# DSOX2004A-03

## S E R V I C E N O T E

DSOX2004A – Oscilloscope, Mixed Signal, 4 Channel,  
70MHz

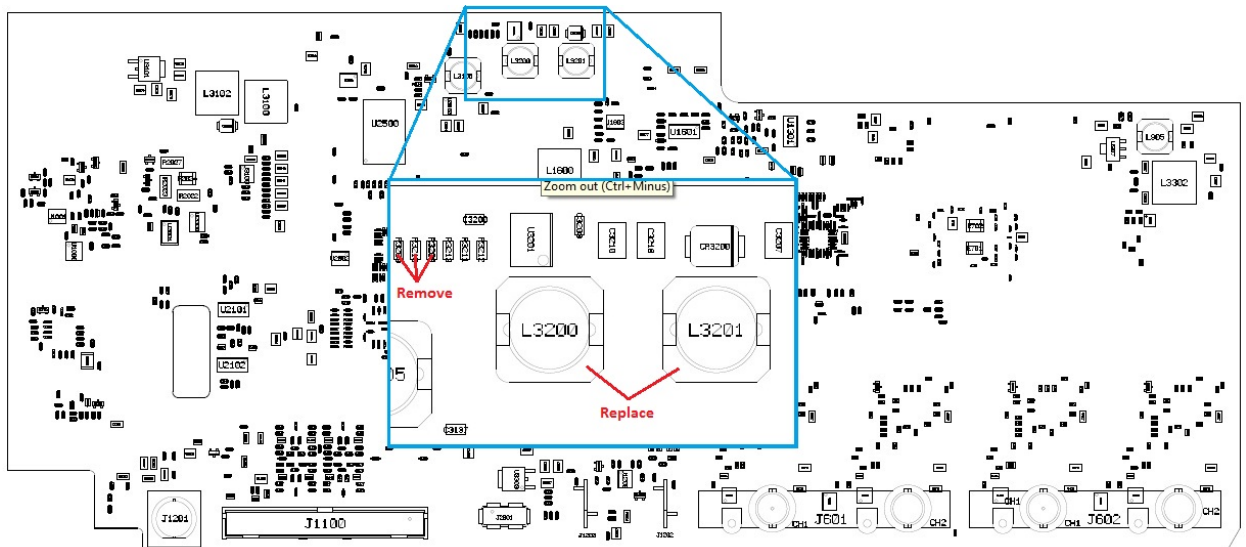
With the oscilloscope power turned on and while under normal operation, the unit emits a hissing noise.

2. As the picture indicates, remove the three resistors (0699-7209, 1 Ohm) located at R3208, R3209, and R3210. They are not to be replaced.
3. Remove as well the two inductors (9140-6474, 100uH) located at L3200 and L3201 and replace them with inductors with part number 9140-6151 (68 uH).
4. Re-assemble to the point where the unit could be powered up to verify that the hissing is indeed gone. If the hissing is not gone, please, check modifications.
5. When the hissing is gone, put oscilloscope back together.
